Response RAI-NF-12

RAI-NF-13

Figure RAI-FF-4.2: Groundwater Pathlines for Nominal Conditions

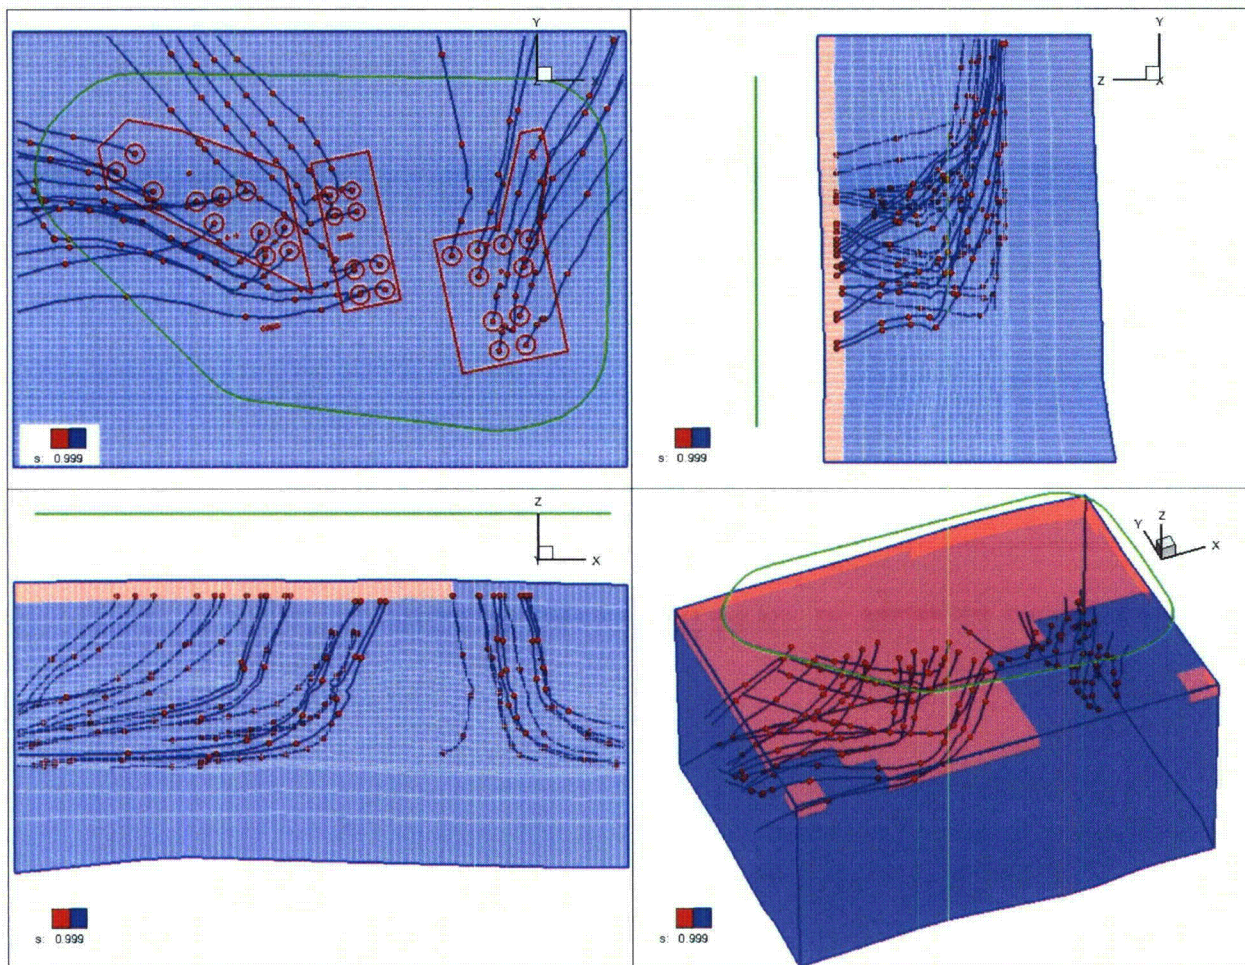
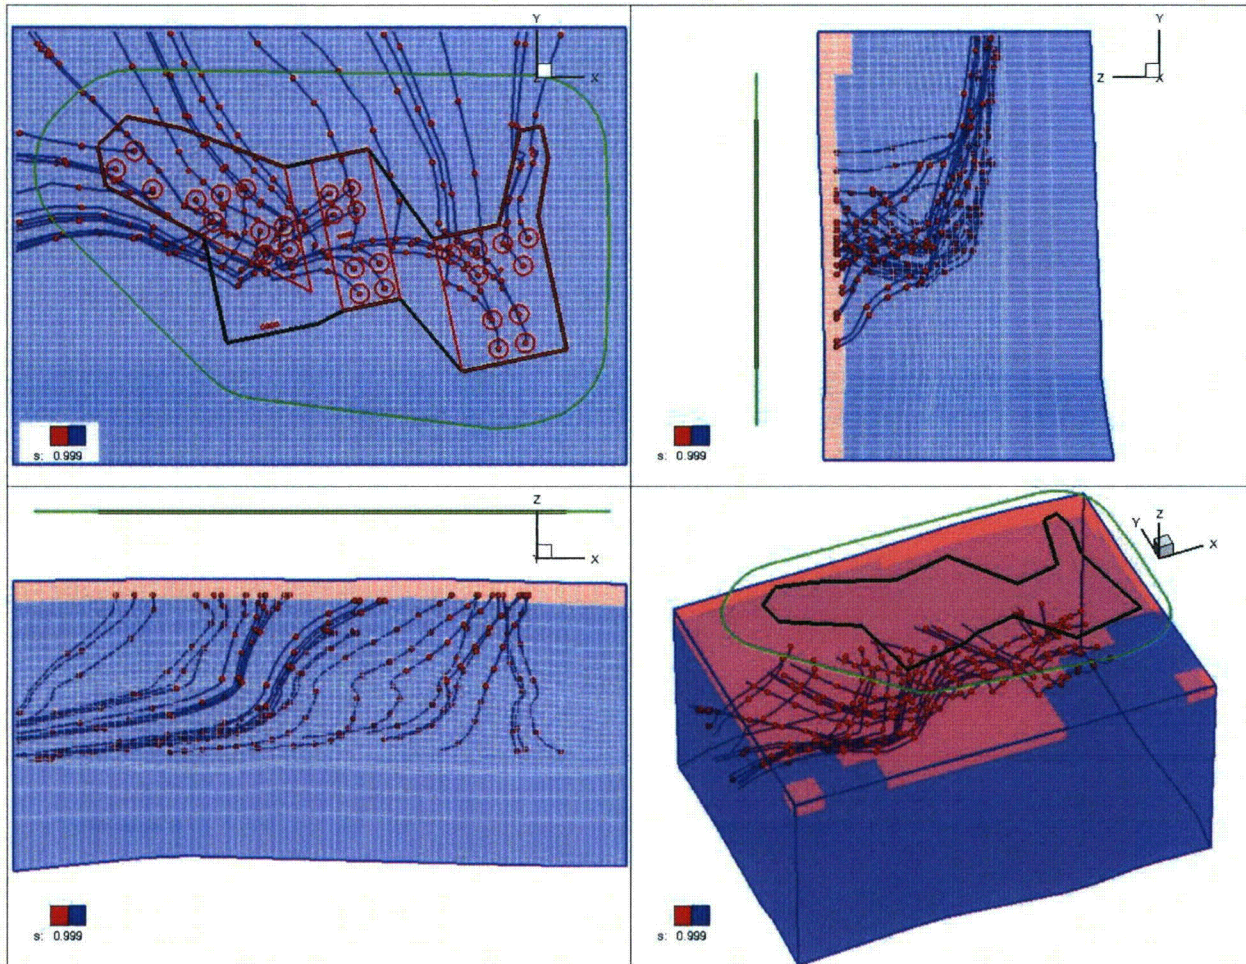
DOE could perform the following activities to evaluate the impact of time-variant recharge and flow at HTF. Note that some of the activities have been partially evaluated in PORTAGE-08-022, Rev. 0. This report can be used as a starting point in addressing this request for additional information but additional detail would be helpful.

To assess the potential impact of a low-permeability cover system over the HTF after final facility closure, a sensitivity study on aquifer flow was performed. Figure RAI-FF-4.2 shows groundwater pathlines emanating from HTF waste tanks for nominal conditions. Figure RAI-FF-4.3 shows the corresponding pathlines when the surface recharge is reduced by 100× over the area coinciding with the 1-meter facility boundary used for dose calculations. The general impact of the cap is to push groundwater deeper and toward the north.

Figure CC-FF-1.4: Concentration Plume (mol/L) Formed by the Release of a Conservative Constituent from Tank 41

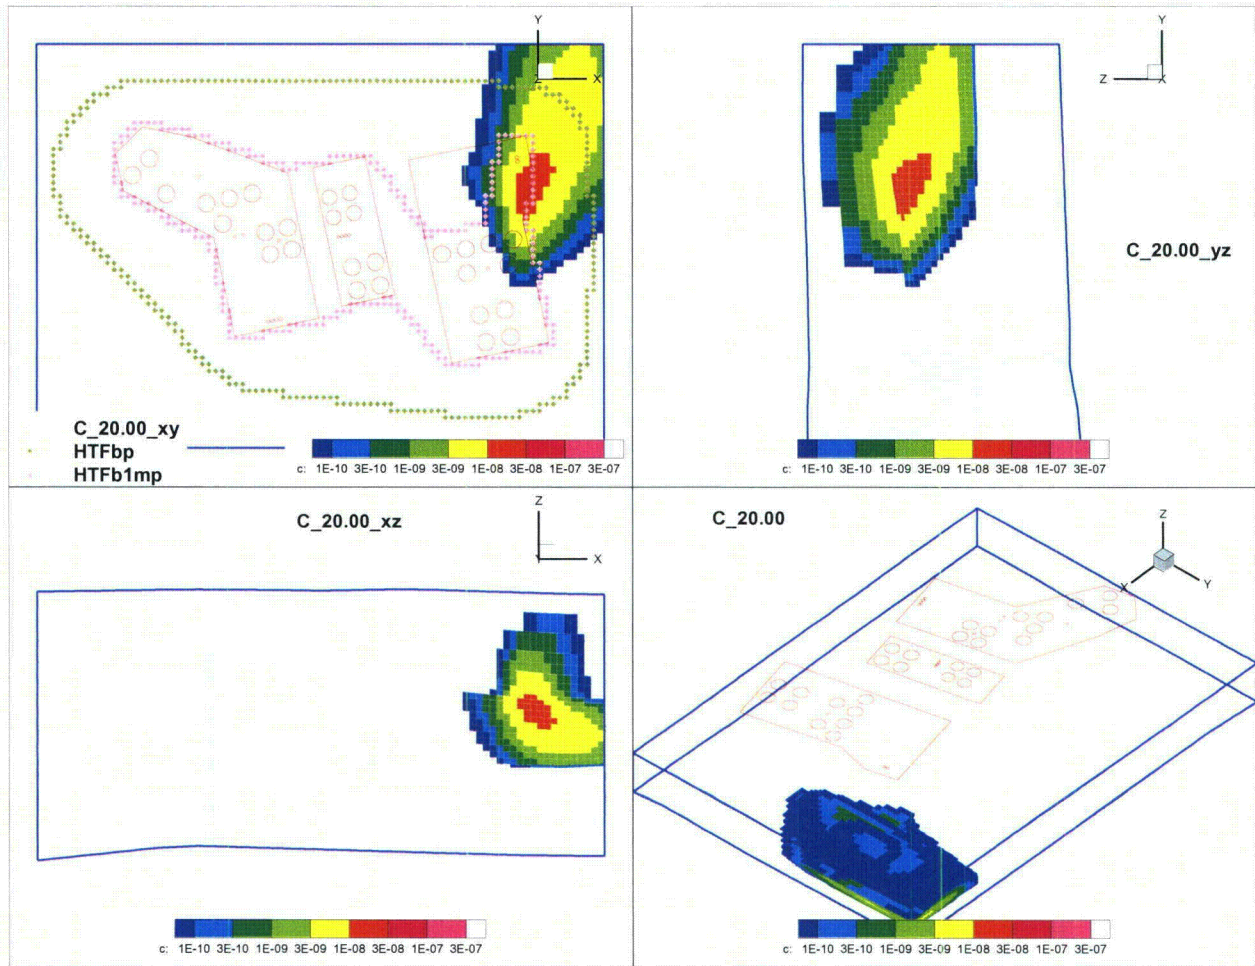
Page 59 of SRR-CWDA-2010-00093, Rev. 2 indicates that some HTF plumes are spread over both aquifers and that higher vertical dispersivities are generally needed for the eastern plumes. Clarify what tank sources are spread over both aquifers and the differences between vertical dispersion for western versus eastern sources in GoldSim® probabilistic modeling.

These new plume figures (Figures CC-FF-1.1 through CC-FF-1.10) show that most of the contaminant resides in the UTRA-LZ at the 100-meter point. Low concentrations ($< 3E-10$ mol/L) of contaminant occur in the UTRA-UZ in plumes emanating from Tanks 39, 40, 49, and 51 as shown in Figures CC-FF-1.2, CC-FF-1.3, CC-FF-1.8, and CC-FF-1.10, respectively. Higher concentrations ($> 3E-10$ mol/L) of contaminant occur in the UTRA-UZ in plumes emanating from Tanks 41 and 43 as shown in Figures CC-FF-1.4 and CC-FF-1.6, respectively.

Figure CC-FF-2.1: Plume Generation in Uniform Flow Fields for (a) Steady and (b) Instantaneous Sources

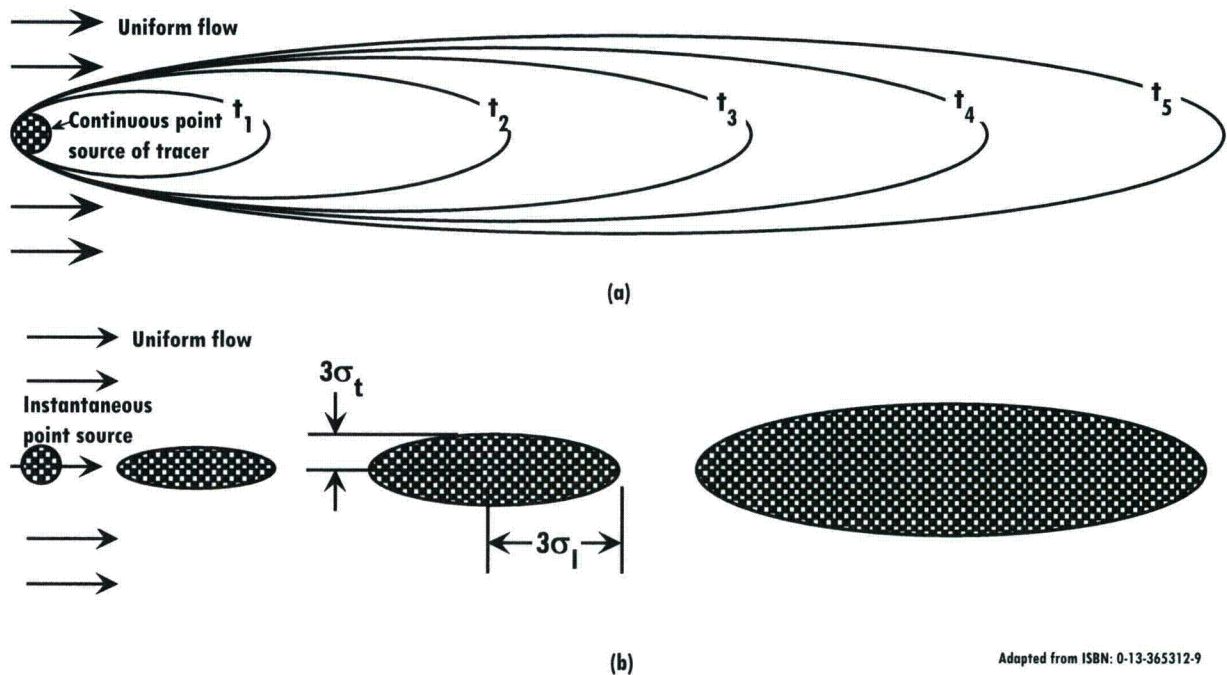
Page 60 of SRR-CWDA-2010-00093, Rev. 2 indicates that differences in flow directions were more significant for western sources, leading to the need for higher transverse dispersivities for western sources. Clarify the degree of transverse spreading for various sources at HTF and how changes in transverse dispersivity in GoldSim® probabilistic modeling are used to simulate the effect of changing flow directions.

When carrying out HTF modeling, it is difficult to match the degree of plume spreading and associated increase in dilution generated by the fully, 3-D PORFLOW model, with the quasi-3-D GoldSim abstraction of the PORFLOW model. On the western side of the HTF, a groundwater divide, spatially divergent flow, and changes in flow direction enhance the lateral spreading of the plumes generated by waste tank releases. The PORFLOW model solves the advective-dispersive transport equations in a fully, 3-D framework, and thus considers both lateral dispersion and the divergence of the flow field in its calculations. The GoldSim model is a quasi-3-D abstraction of the PORFLOW model that solves for 1-D advective-dispersive transport along a pathline, and approximates the influences of horizontal and vertical transverse dispersion with Green's function solutions. In this configuration all the effects of the flow field are not fully captured. Confined to evaluating advective-dispersive transport in a unidirectional flow field, the GoldSim model generates typical cigar shaped plumes for steady and instantaneous releases (Figure CC-FF-2.1 (a) and (b)).

Figure CC-FF-4.1: Normalized 100-Meter Concentration Breakthrough Curves for Modeled Source Pulses

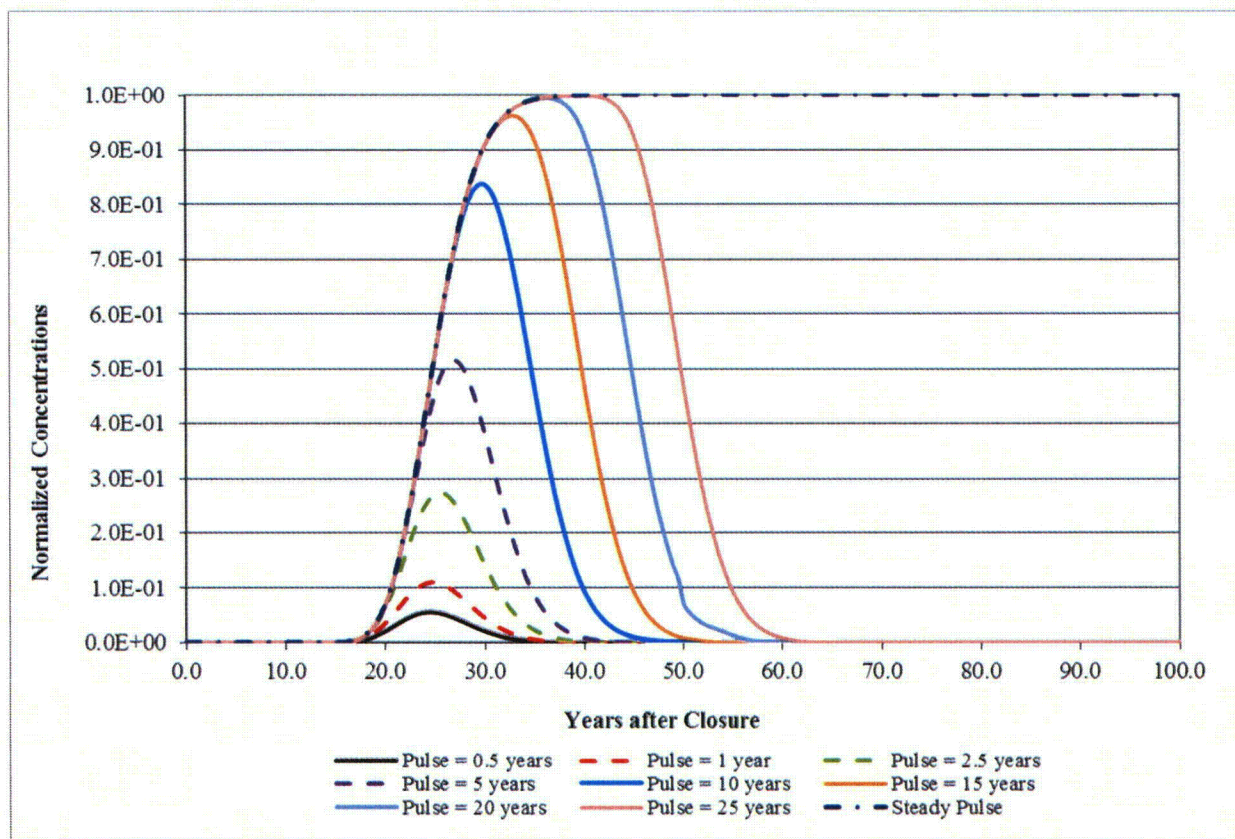
Provide approximate (effective) dilution factors for various HTF sources in GoldSim® probabilistic model considering vertical and horizontal dispersion, as well as additional mixing due to increased dilution at the end of the flow path. Evaluate dilution for various source release profiles such as pulse or continuous releases with respect to peak dose for various source locations and radionuclides.

defined by a separate attenuation factor, and presented in Table CC-FF-4.3. The 100-meter concentration breakthrough curves for each simulation are presented in Figure CC-FF-4.1. Note that the attenuation factors are the inverses of the peak values of the normalized breakthrough curves presented in Figure CC-FF-4.1. Due to the model parameters used, the dilution factor for a 25-year pulse essentially equals the steady pulse after 25 years. A complete dilution factor can then be defined as the product of $DF_{Effective}$ and the attenuation factor.

Figure CC-INT-1.7: Case E Chronic IHI Dose

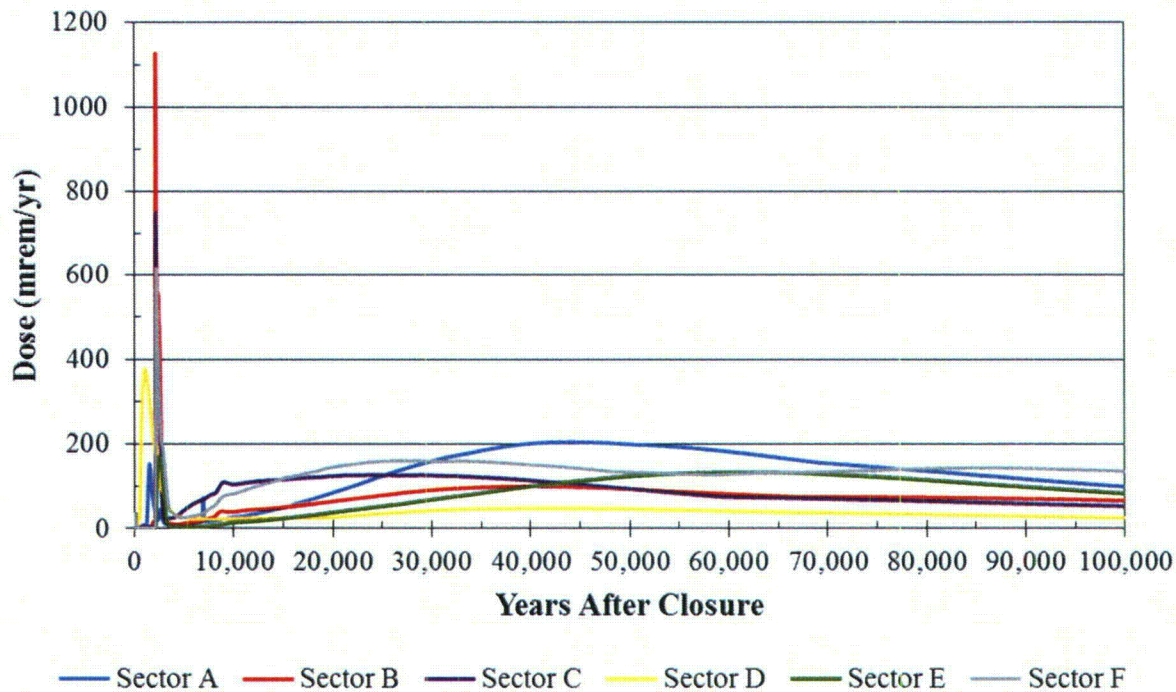
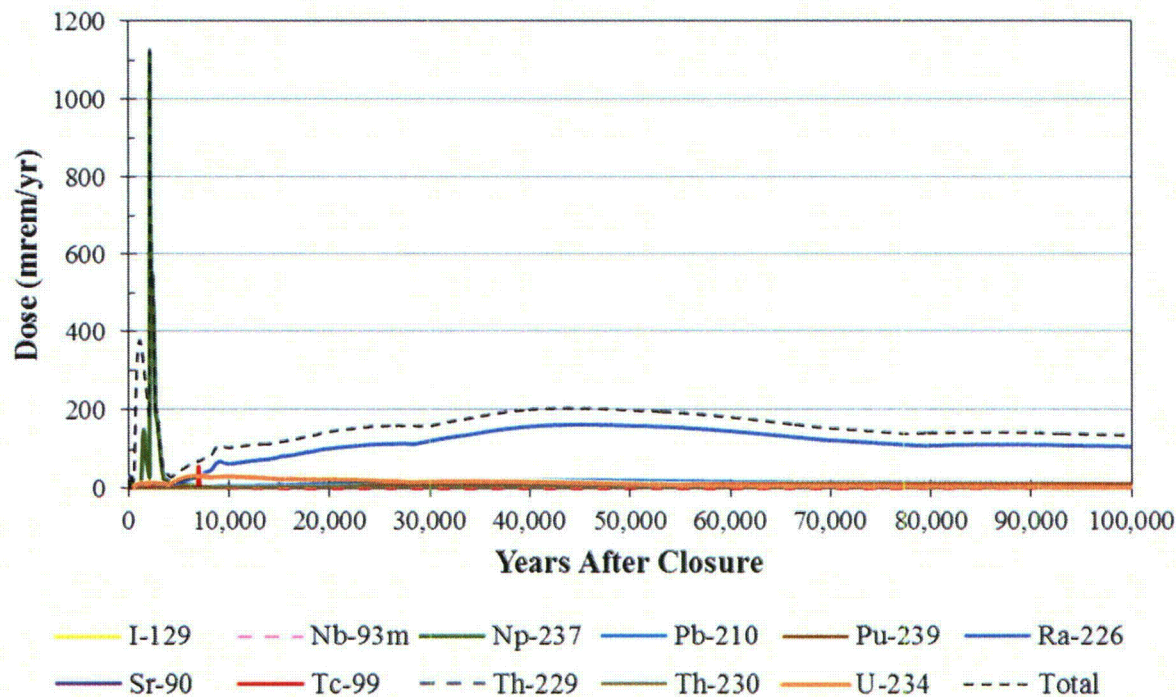
Provide detailed results for alternative case E.

The chronic IHI dose for Case E was estimated to peak at 1,127 mrem/yr (at 2,160 years after HTF final facility closure), as shown in Table CC-INT-1.1 and Figures CC-INT-1.7 and CC-INT-1.8 of the response to CC-INT-1. Case E is considered the least probable configuration out of the scenarios identified in Table CC-INT-1.1 (see Section 5.6.3.2 of the HTF PA and the response to RAI-NF-10).
